HORSHAM DISTRICT COUNCIL CONSULTATION

TO:	Horsham District Council – Planning Dept
LOCATION:	Land North West of Southwater
DESCRIPTION:	Outline planning application, with all matters reserved (except for primary access to the highway) for a phased development comprising: the demolition of existing buildings and the construction of residential dwellings (including affordable housing) (Use Classes C2 and C3); a mixed-use neighbourhood centre (Use Classes E and F); education facilities (Use Class F1(a)); business and employment floorspace (Use Classes B2, B8 and E(g)); redevelopment of existing agricultural buildings including construction of a building for community use (Use Classes E and F2); improvements to public rights of way; sports pitches; gypsy and traveller pitches/plots; public open space; landscaping, and associated infrastructure.
REFERENCE:	DC/26/0366
RECOMMENDATION:	No Objection / More Information / Modification No Objection subject to more information and modifications to be secured by condition

Contextual wider panoramic extent of the view

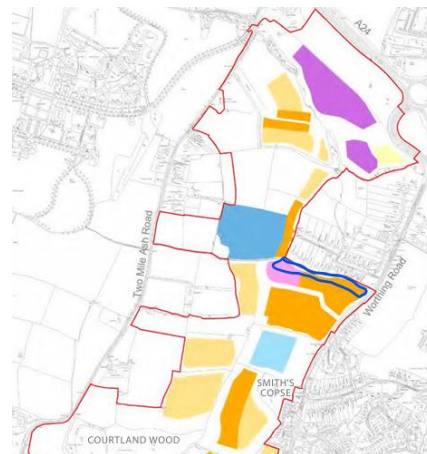
The LVIA identifies the effects of the proposed development on users of prowl 1662 (VP 06) as major adverse at year 1, reducing to a residual moderate adverse effect over time. An extract of VP06 is copied below.

Site observations and the accompanying V06 photograph indicate that existing vegetation along the section of the prow adjacent to this most western field is limited and kept at a lower height along Two Mile Ash road. The retention of the current boundary treatment is desirable, as the field remains intrinsically reflective and connected to the existing field pattern, and no development is proposed at this stage within this field, nevertheless careful consideration must be given to strike the right balance between retention of existing character and softening/ filtering of views. With this in mind, a future reserved matters application should adopt a light touch approach to the field's boundary, mostly limited to gaping up where required with the understating that this approach may need to be reviewed, should future proposals for school expansion come forward. To be addressed by condition

Parameter Plans – **Storey Heights**

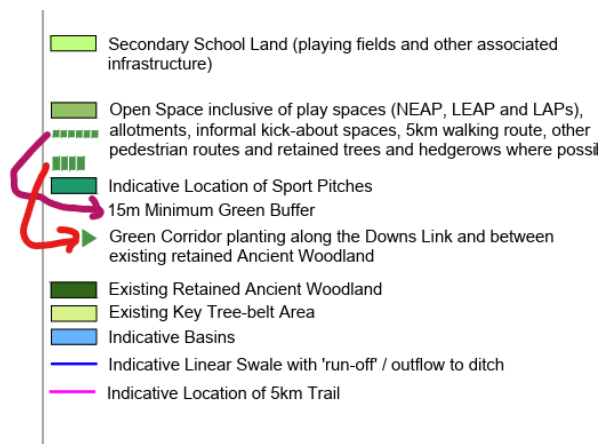
5. Recommend the areas indicated in the mark-up to be proposed as 2 storey (9m) instead of the proposed 3 storey/ mixed use (12m ridge). **Closed**
